Project	IEEE 802.16 Broadband Wireless Access Working Group < http://ieee802.org/16 >	
Title	Modification of Sleep mode SDL	
Data Submitted	2004-06-25	
Source(s)	Jaesun Cha ETRI 161, Gajeong-dong, Yuseong-Gu, Daejeon, 305-350, Korea	Voice: +82-42-860-5587 Fax: +82-42-861-1966 jscha@etri.re.kr
Re:	This is a response to a Call for comments about IEEE802.16e-D3	
Abstract	The document contains suggestions on modification of Sleep mode SDL	
Purpose	The document is submitted for review by 802.16e Working Group members	
Notice	This document has been prepared to assist IEEE 802.16. It is offered as a basis for discussion and is not binding on the contributing individual(s) or organization(s). The material in this document is subject to change in form and content after further study. The contributor(s) reserve(s) the right to add, amend or withdraw material contained herein.	
Release	The contributor grants a free, irrevocable license to the IEEE to incorporate material contained in this contribution, and any modifications thereof, in the creation of an IEEE Standards publication; to copyright in the IEEE's name any IEEE Standards publication even though it may include portions of this contr

Figure 130d – Typical MSS Listening SDL diagram

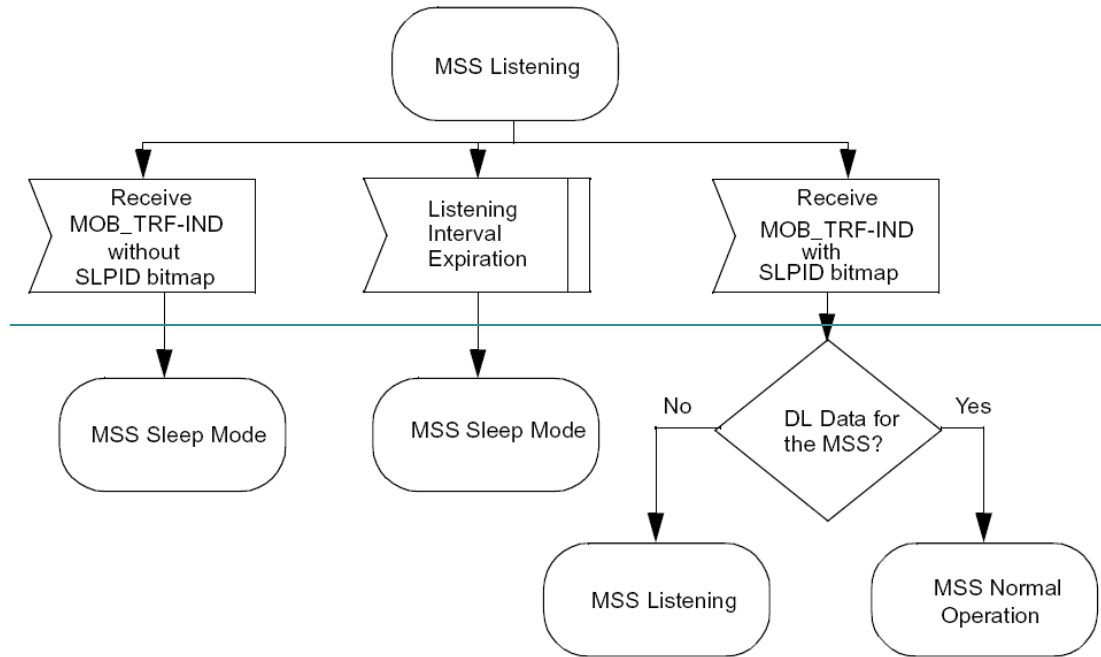
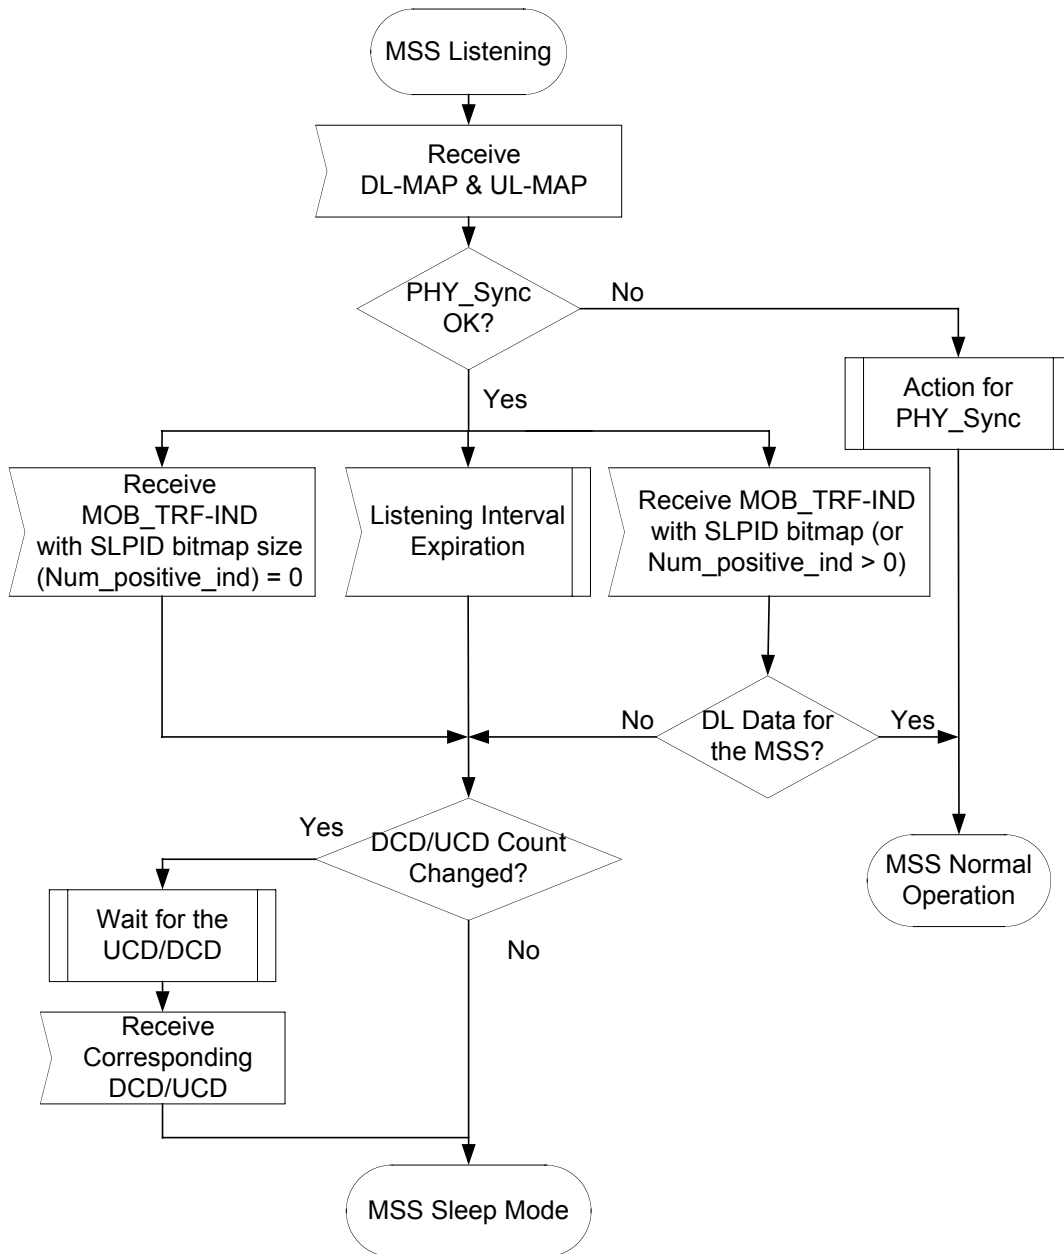
[Change Figure 130d –Typical MSS Listening SDL diagram from:]

[to:]

Figure 130g – BS-MSS Sleep Mode SDL Diagram

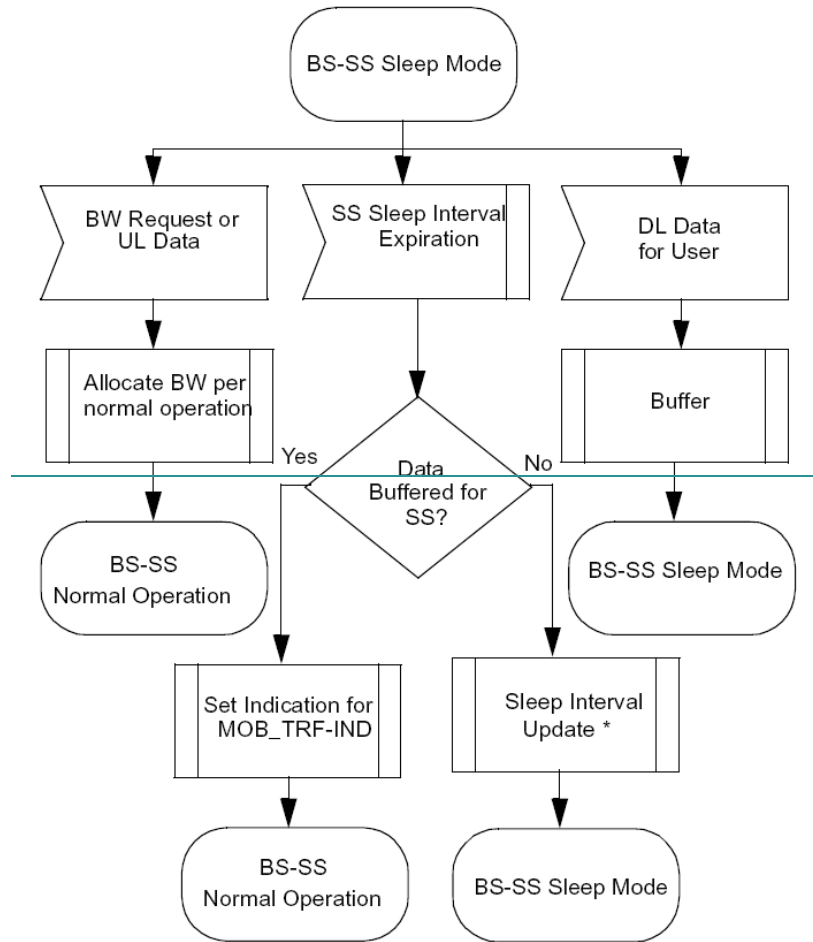
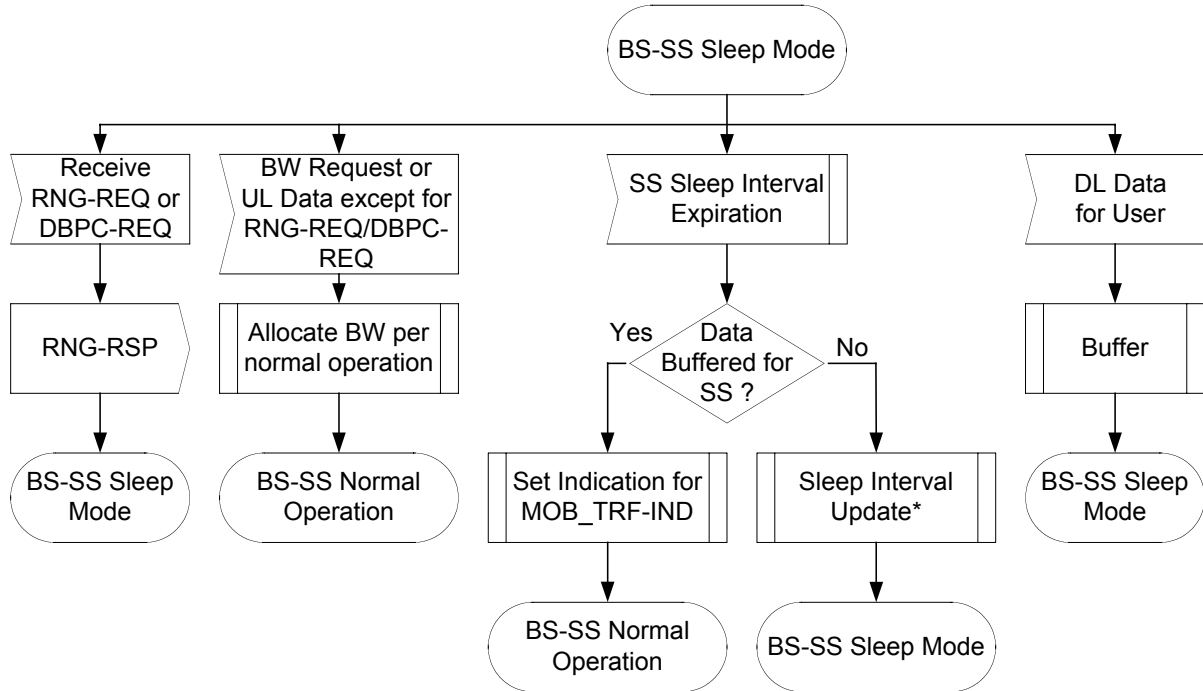
[Appropriately Change the Figure 130g from:]

[to:]
